Date January 15, 2020
To Town of Cumberland Planning Board
From Carla Nixon, Town Planner
Subject **Amendment to Major 52 Unit Major Subdivision, OceanView at Cumberland –
277 Tuttle Road**

***PROPOSED AMENDMENT-1 – REPLACE PHASE 1 COMMUNITY CENTER WITH NEW UNIT #53
(Map R04 Parcels 4E and 5)***

AMENDED SUBDIVISION PLAN
Oceanview at Cumberland
(Cumberland Crossing Phase-1)
Tuttle Road Cumberland, Maine

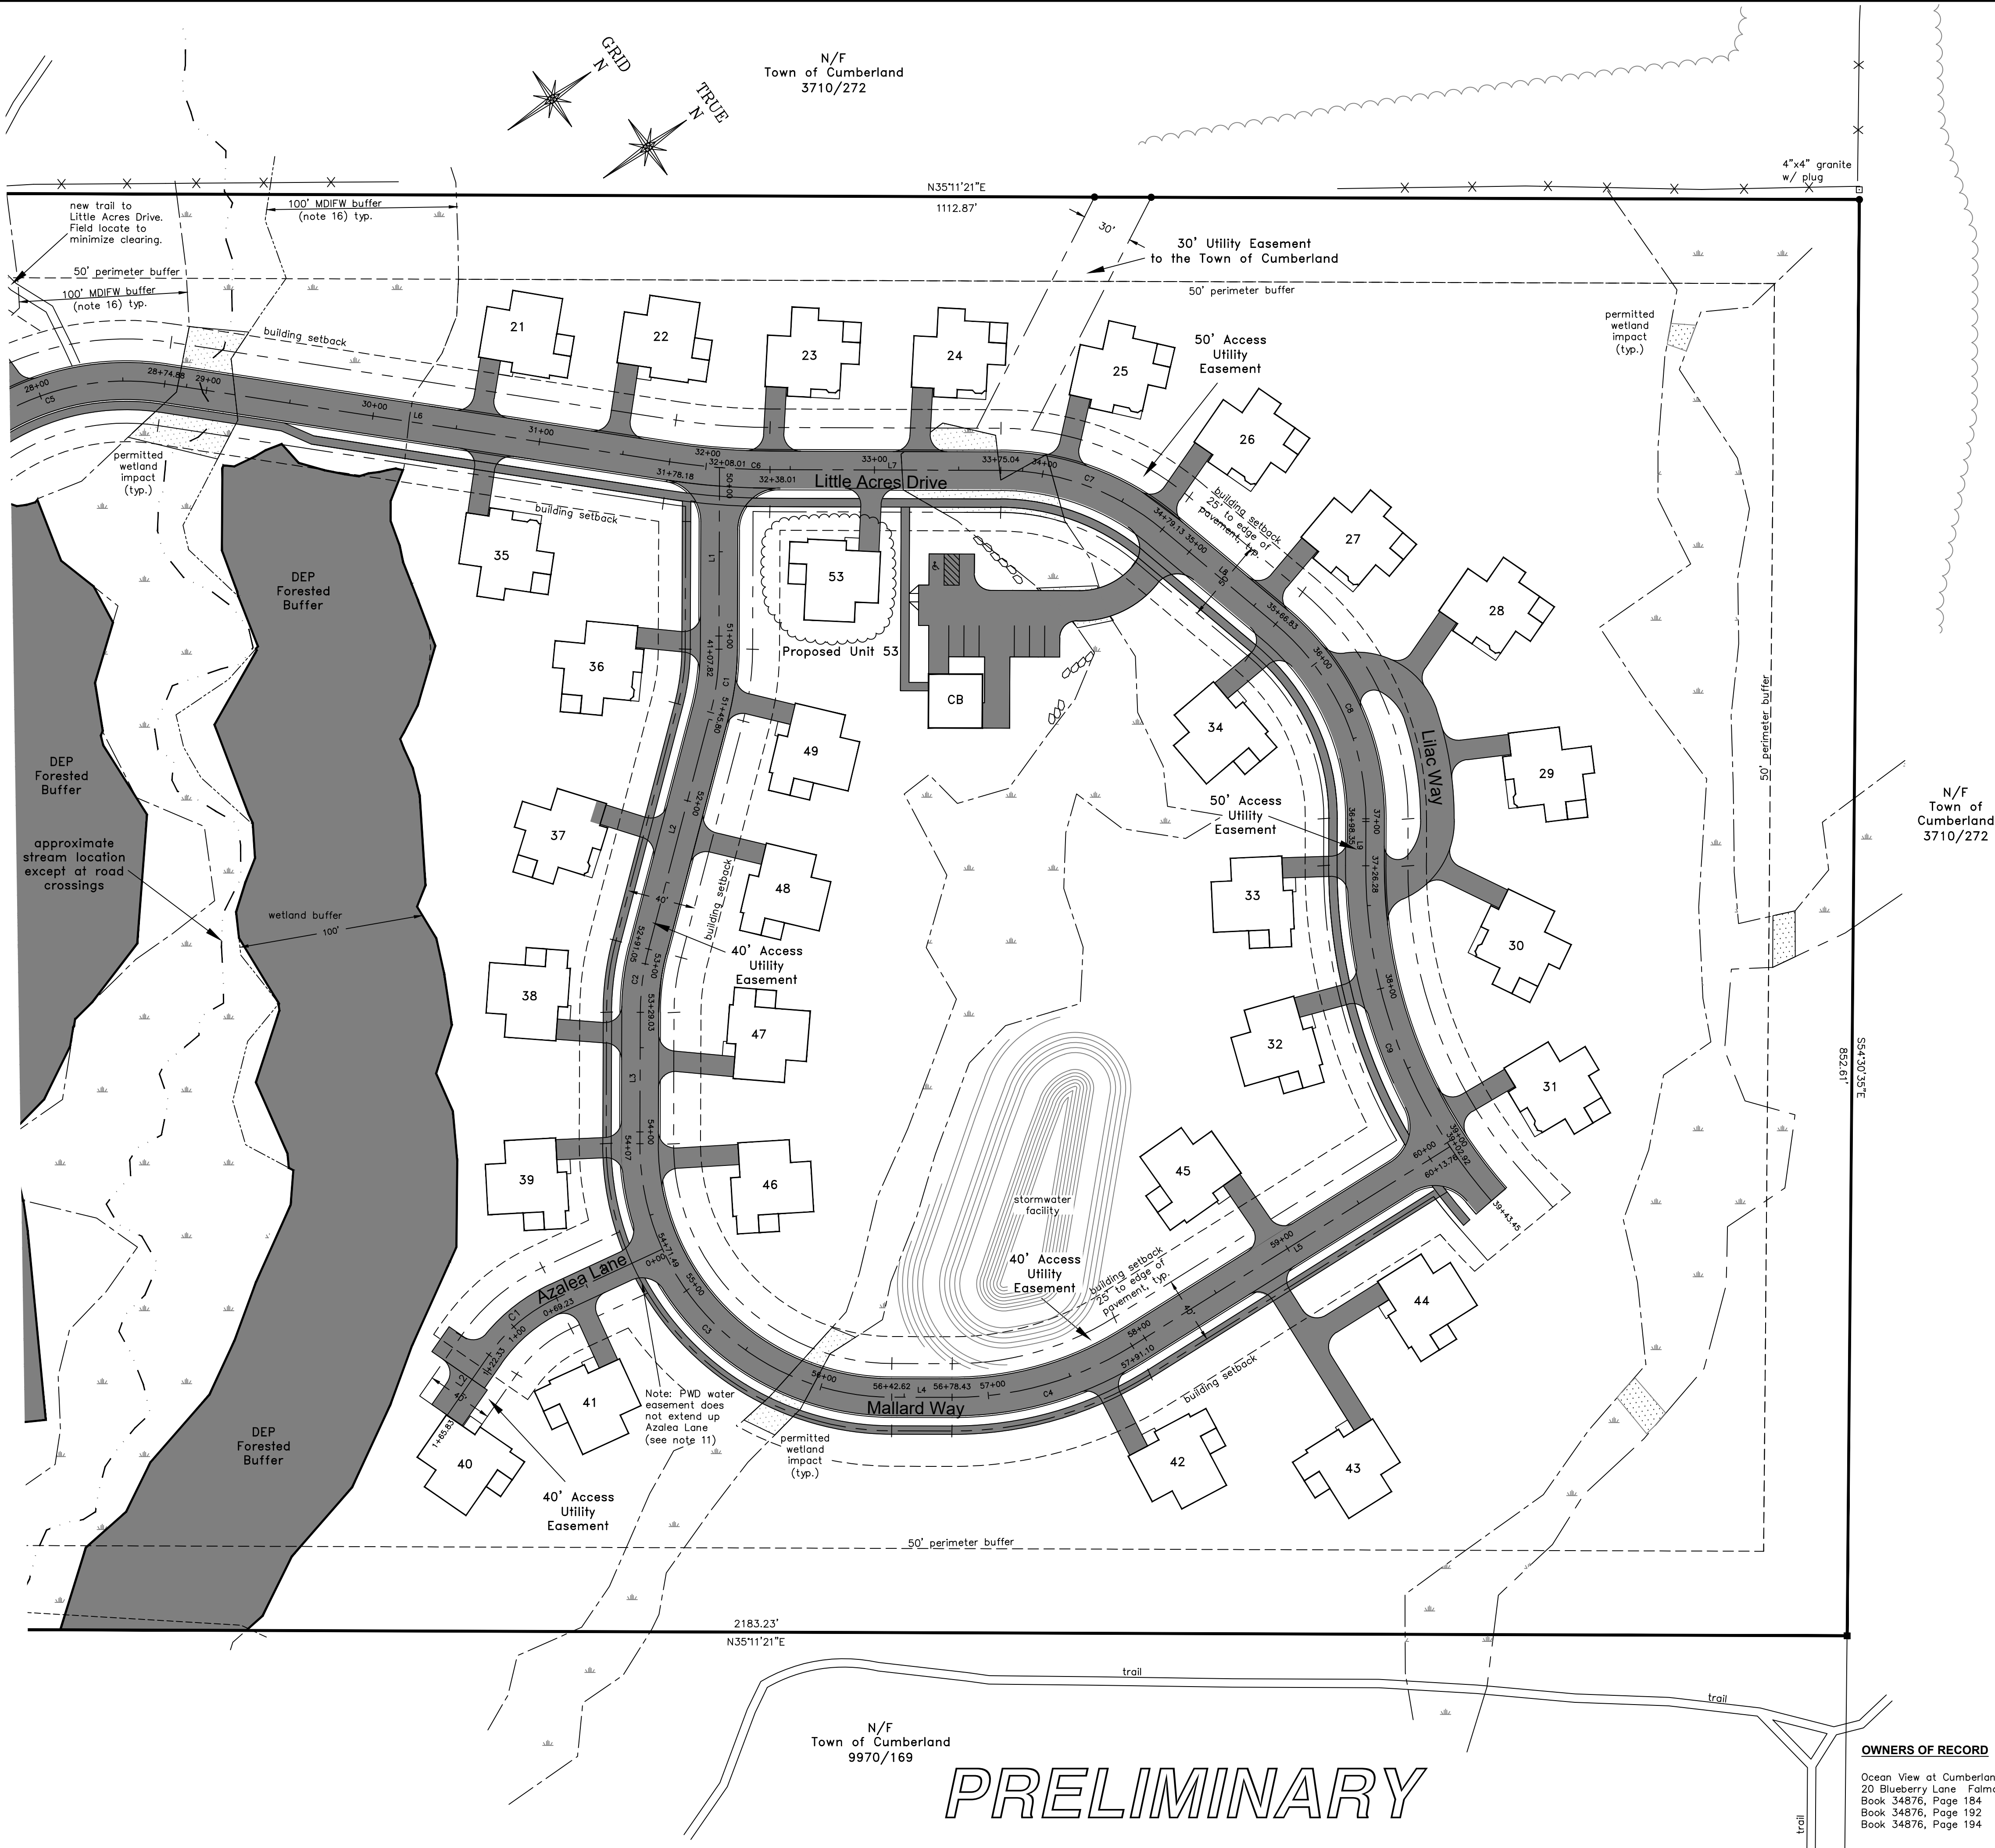
**OCEANVIEW AT CUMBERLAND - PHASE 1
AMENDMENT NOTES**

- 1) This plan amends the approved subdivision plan entitled -Subdivision Plan, Oceanview at Cumberland, Tuttle Road, Cumberland, Maine made for Oceanview at Cumberland LLC, 20 Blueberry Lane, Falmouth, Maine 04105 rev. date 07/31/18 and approved by the Cumberland Planning Board on August 21, 2018 and recorded in the Cumberland County Registry of Deeds in Plan Book 218 Pages 411-414.
- 2) The revisions to the plan under this amendment include:
 - a. Changing the proposed community center located on Little Acres Drive to a new Cottage Unit #53.
 - b. Minor pavement adjustments at the approved maintenance garage area adjacent to the new Unit #53.
 - c. The total unit count for phase 1 is changed from 52 to 53 units.

Site Development Plan

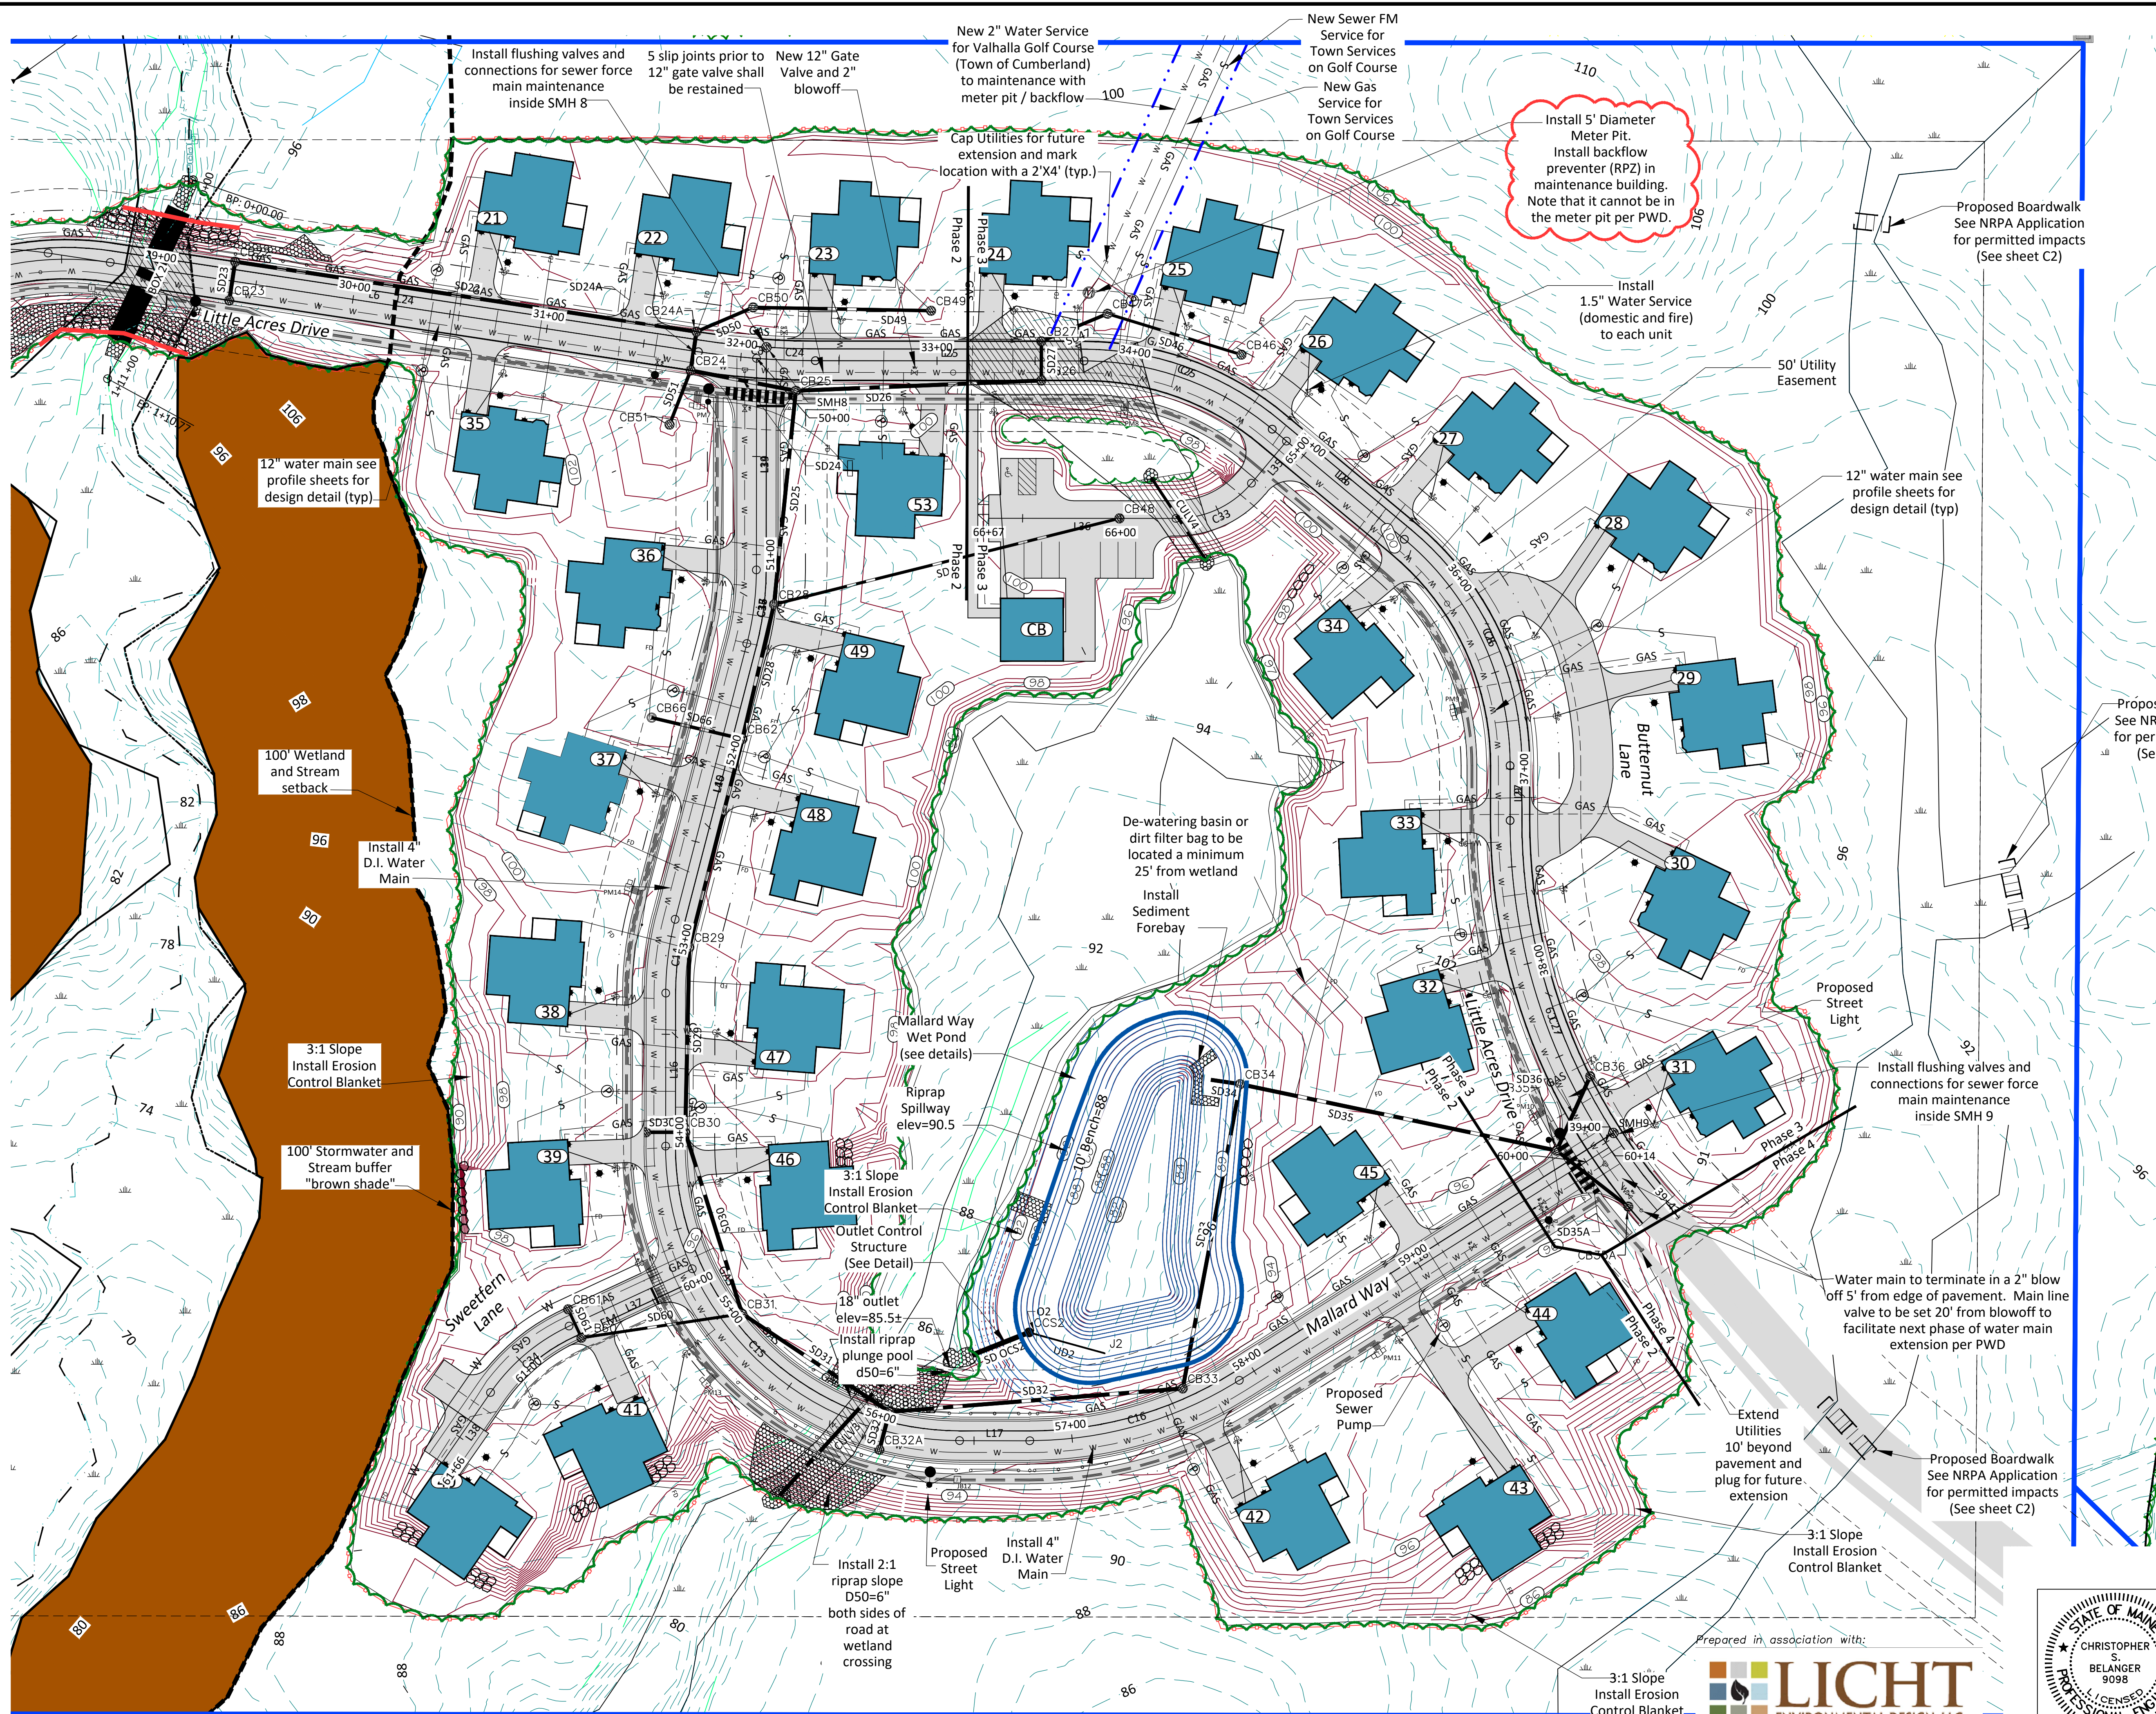
| 13. | 11-27-2019 | Require back flow preventer be installed in maintenance building (not in meter pit). Submit to PWD | CSB |
| 12. | 11-6-2019 | Revisions per PWD markup, Add 5' diameter Meter Pit at Valhalla service | CSB |
| 9. | 12-4-2018 | Remove Community Building, Add Unit 53 | CSB |
